CapX Hampton-Rochester-La Crosse Transmission Line Project

PUC Docket Number: E002/TL-09-1448

Figure 11

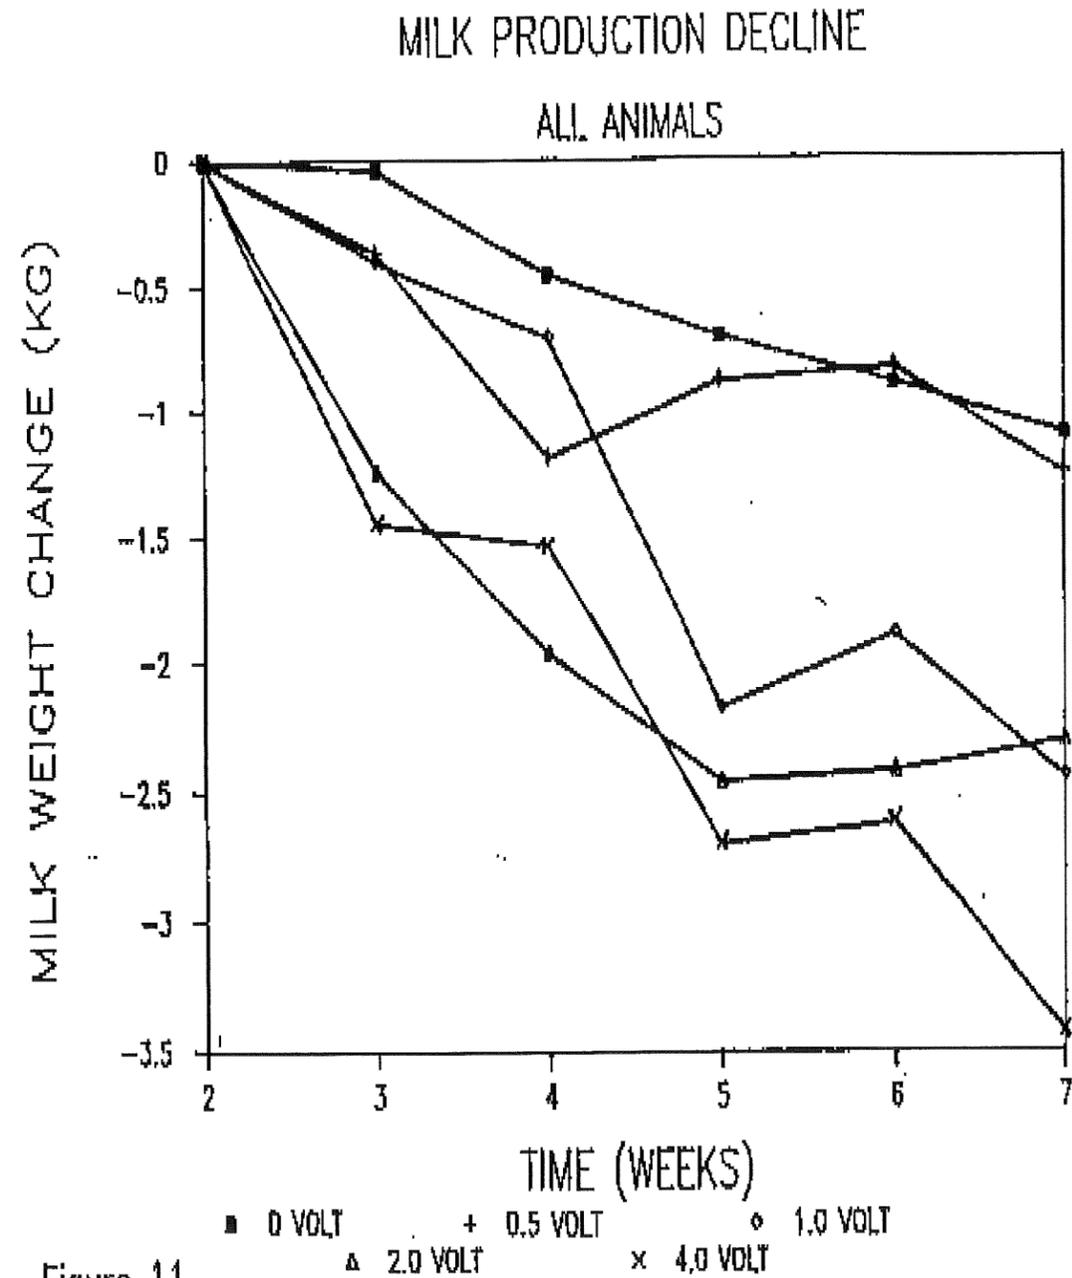
- 4.) McGill University, Montreal, Quebec studied the effects of electric and Magnetic fields on dairy cows. The findings were as follows: 1. Milk production decreased 5% 2. Fat-corrected milk decreased 14% 3. Milk fat decreased 16% 4. Dry matter intake increased 5%. **Measurable problems** (See enclosed article) **Has the State of MN included this within the scope of the Environmental impact statement?**

Figure 2A

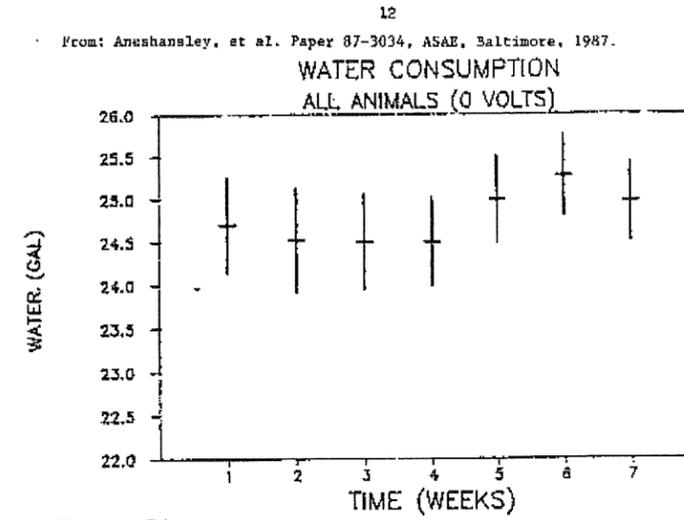
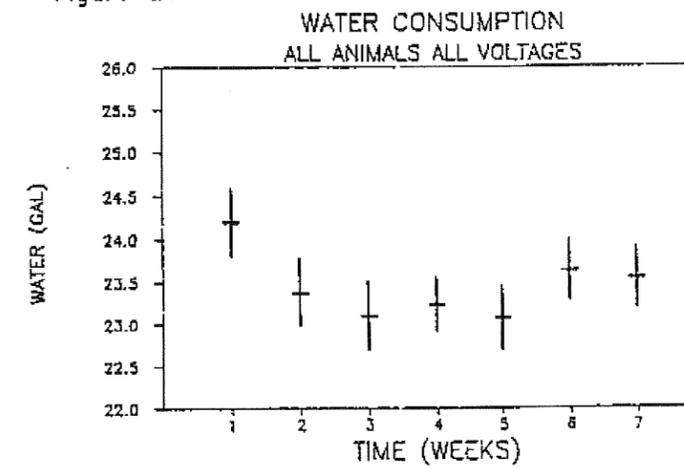
Trends were apparent for "Water Consumption," Figures 2A vs 2B (Appendices), "Feed Consumption" Figures 12A vs 12B (Appendices), and possibly "Milk Fat" Figure 14A vs 14B (Appendices). Gorewit et al. (8) on the same experiments in the Journal of Dairy Science did not mention the significant differences at week 5 and did not present the graphic figures from the ASAE report. However, they did report that two animals receiving 4 volts did not drink for 36 h, at which time their voltages were disconnected. [And] "All other animals drank within 36 h and showed no significant long-term difference in the monitored parameters." This is not consistent with the Aneshansley report (1) where milk production was affected by a wide range of low voltages. Addition of 44 more cows to their numbers for a 2 d water and feed consumption and milk production "experiment" where they found four more cows that did not drink for 36 hours drew their conclusion: "... no significant long-term difference in monitored parameters." Variances, small numbers, and limited time exposure render contribution doubtful for describing on-farm expectations from stray voltage.
